**PPL Bell Bend, LLC**  
Two North Ninth Street  
Allentown, PA18101-1179  
Tel. 610.774.7552 Fax 610.774.2618  
[rrsgarro@pplweb.com](mailto:rrsgarro@pplweb.com)

**BELL BEND NUCLEAR POWER PLANT  
ENVIRONMENTAL AUDIT NEED FOR  
INFORMATION RESPONSES:  
SIXTH SUBMITTAL  
BNP-2012-167      Docket No. 52-039**

**Need for Information Responses**

Figure 1 - Meteorological Tower Forest Measurements

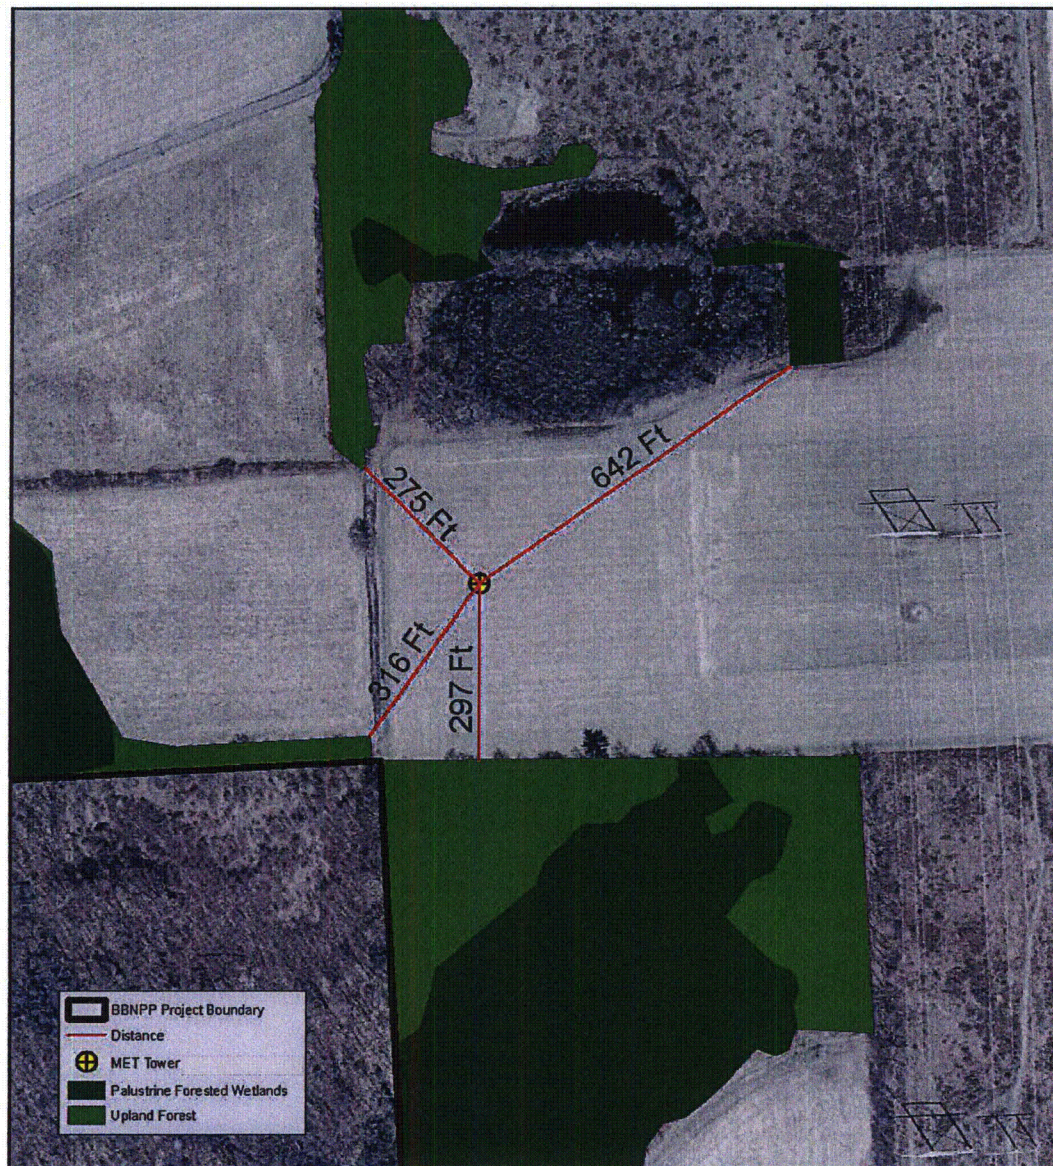
**MET-04: Discuss SSES and BBNPP meteorological tower locations and possible obstructions due to nearby vegetation or from changes in the BBNPP structure location.**

During the Environmental Audit, the NRC reviewed the MET-04 NFI response and toured the proposed meteorological tower location. During the tour, NRC indicated that the proposed site appeared appropriate for the siting of the meteorological tower, but requested information on the potential impact of EMF from nearby transmission lines and an assessment of the potential for meteorological tower tree obstructions. The response below responds to this request for additional information.

As designed, the proposed tower will be constructed at a location greater than five obstruction heights from nearby treelines without additional tree clearing, as described in Table 1 and shown on Figure 1. Standard Review Plan guidance indicates that when towers are sited more than five obstruction heights from major obstructions, the influence from the obstruction should be minimal. Analysis of the proposed tower location supports a conclusion that influences from the nearest treelines will have minimal, if any, influence on atmospheric measurements in this location.

- Height of nearby obstructions: The nearest treelines are to the north and south of the proposed tower location, and are at a distance from the tower of greater than 5 times their height. These nearest treelines are not in line with the prevailing wind directions. Proposed upland tree clearing of approximately 125' at the southern treeline will be completed to support planned construction activities, increasing the ratio of distance to obstructions included in Table 1, further reducing the potential for interference.

- Prevailing wind direction: Per ER 2.7.1.1, the prevailing wind directions are ENE and SW. In both of these directions, there are longer fetches to obstructions (treelines) than to the N and S, and in the case of the predominant wind direction, the distance from the tower to the ENE treeline approaches a factor of 13 times the obstruction height (Table 1).

- Nearby Land Use and Obstructions: There are no treelines, buildings, or other structures within 10 obstruction heights to the E, W, NW, or SE, and tree density to the NNW and SW is lower than to the N and S.
